STAFF REPORT

REGIONAL CENTER HEARING EXAMINER – HIGH IMPACT CASE

Case Number	2026-REG-006
Address (approx.)	219 Koehne Street, 1437 – 1533 (odd) Saulcy Street, and 1422 – 1528 (even) Astor Street
Location	Center Township, Council District #18
Petitioner	Union Holdings III, LLC, by Misha Rabinowitch
Zoning	D-8 (RC)
Request	Regional Center Approval to provide for demolition of existing dwellings and accessory structures and for construction of a multi-family residential development, consisting of approximately 242 units, an integrated parking garage with 258 spaces, and resident amenities, including a community room, a playground, dog park, and grilling area.

MEMORANDUM OF EXAMINER'S DECISION
2026-REG-006 — Union at Astor
219 Koehne Street, 1437–1533 Saulcy Street, and 1422–1528 Astor Street

Floor Plans

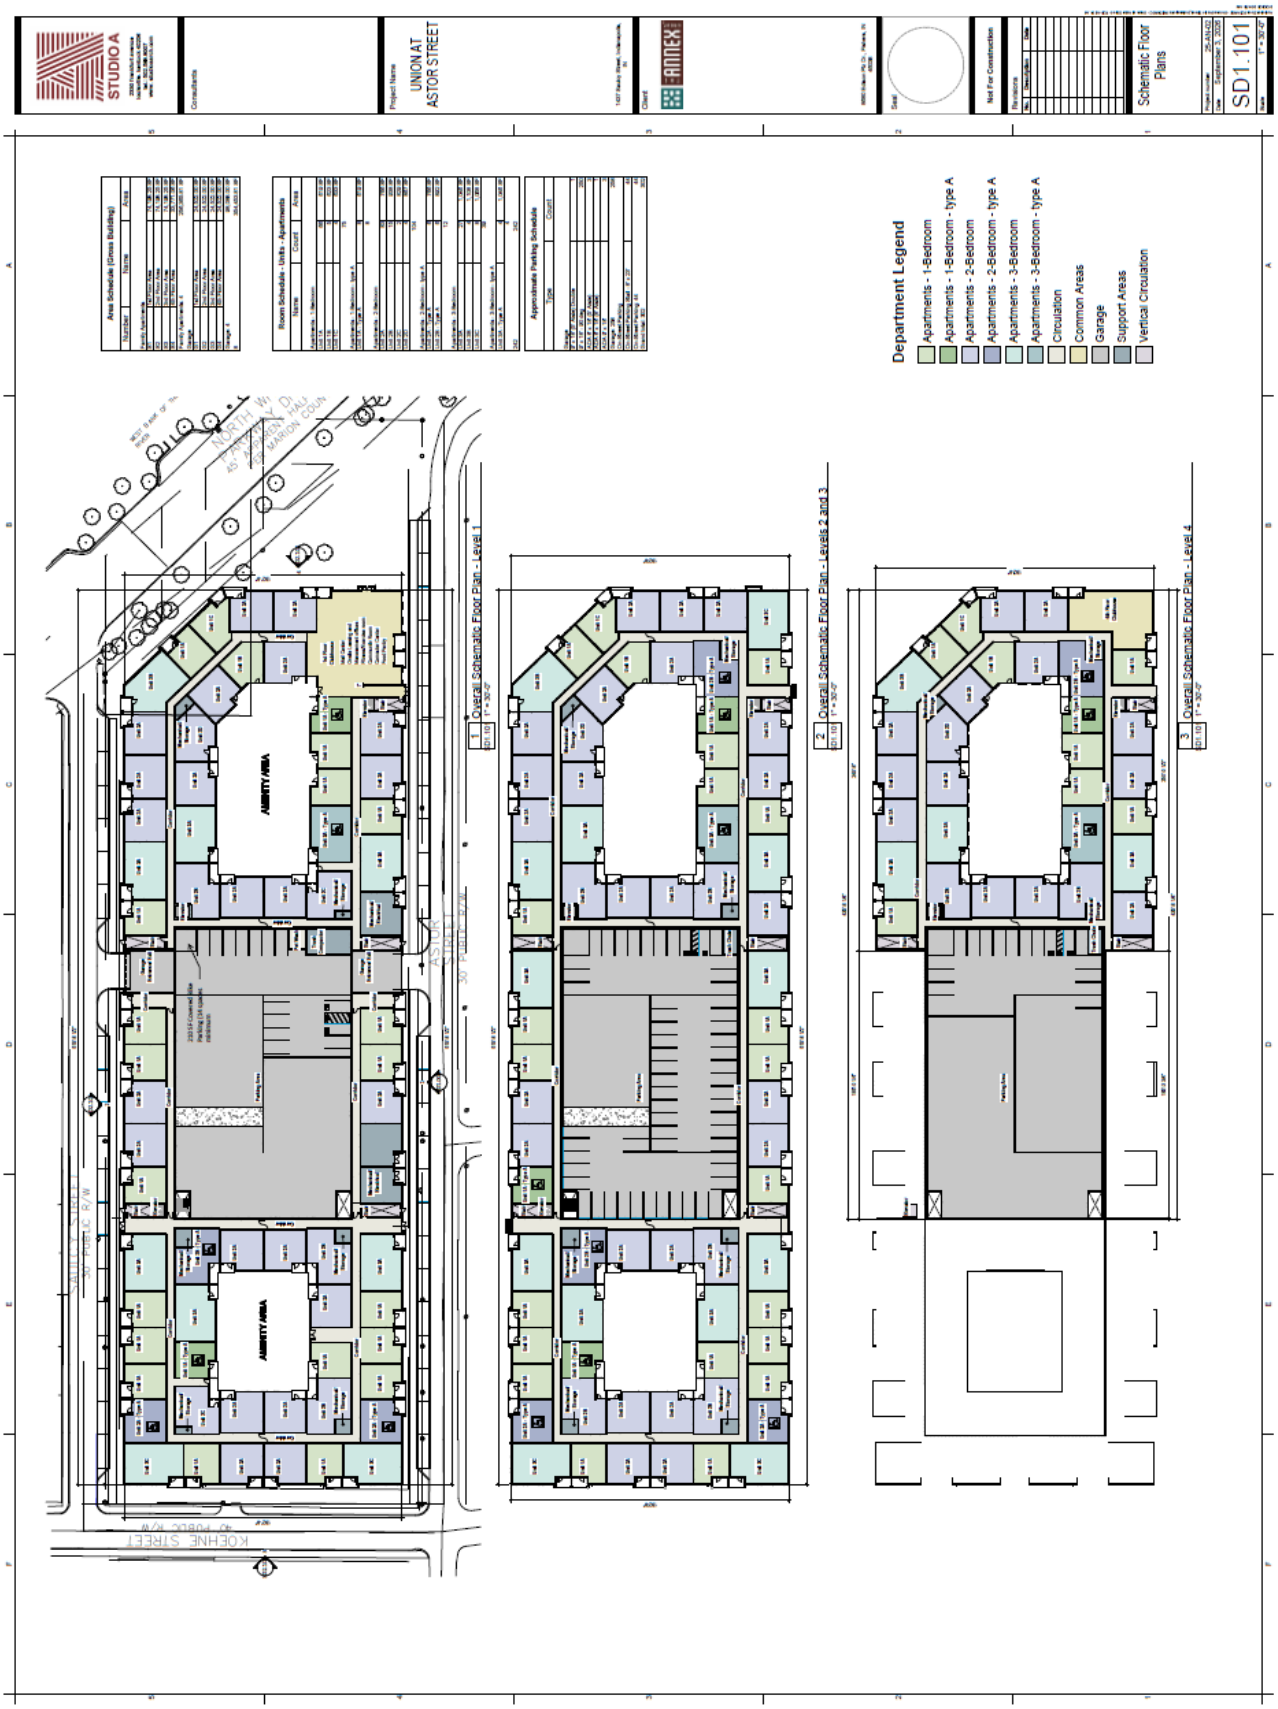
3. Exit doors need to open directly into the pedestrian way and shall be designed to provide safe egress per CA 3.1.5.
4. A lighting plan was not submitted to the file to identify the location of lighting standards. Additionally, a photometric plan has not been submitted to the file. A photometric plan should detail light standards and photometric levels for the site and at each entrance. Lighting must be provided at each entrance and must be dusk to dawn. Only full cut and shielded light standards are permitted with minimum foot-candle power outlined in CA 4.3.2 and CA 4.3.3. Pedestrian areas and entries must be lighted for safety (CA 3.1.3 and CA 4.3.1). A lighting and photometric plan shall be submitted and subject to planning staff review and approval, prior to the issuance of an Improvement Location Permit.

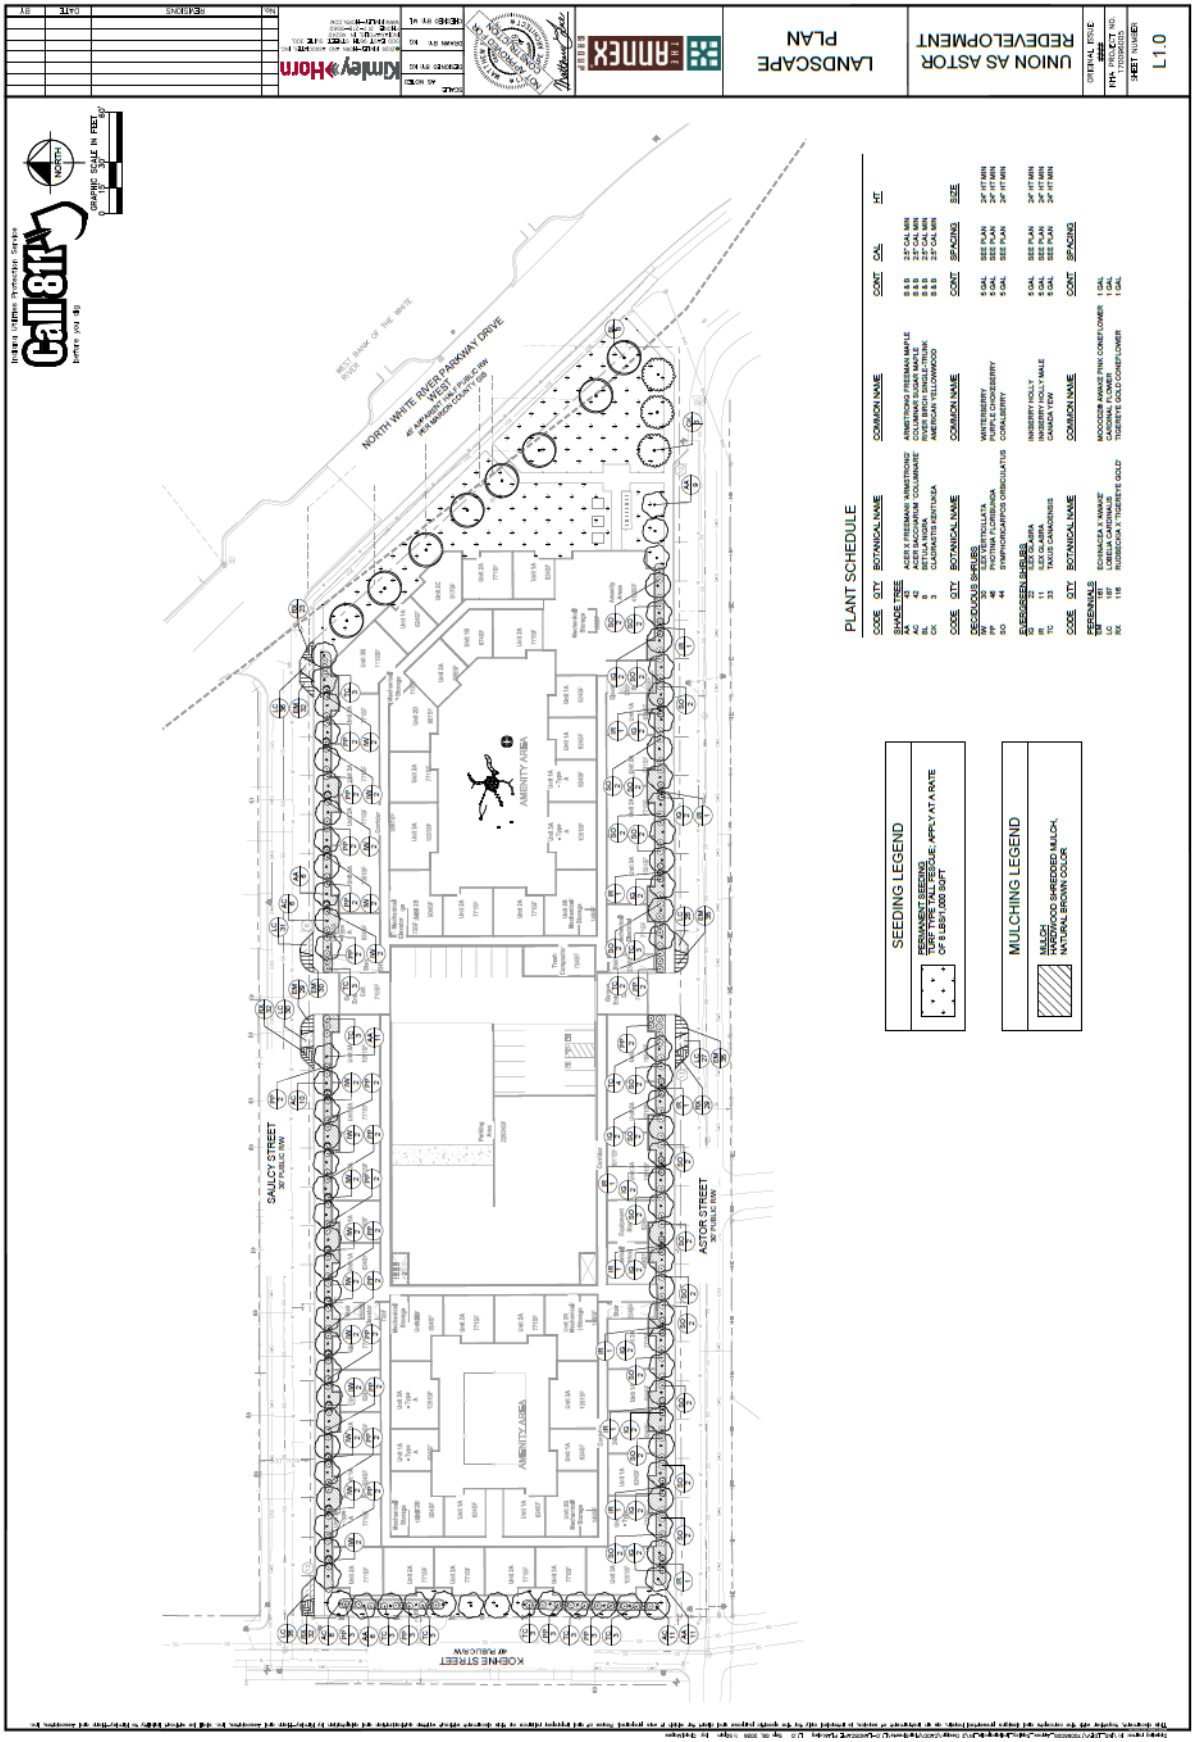
2. The building materials are primarily made of fiber cement, a man-made material. Staff requested additional natural building material. Subsequent revised elevations note added areas of brick on the façade. Guideline CA 2.2.1 applies.
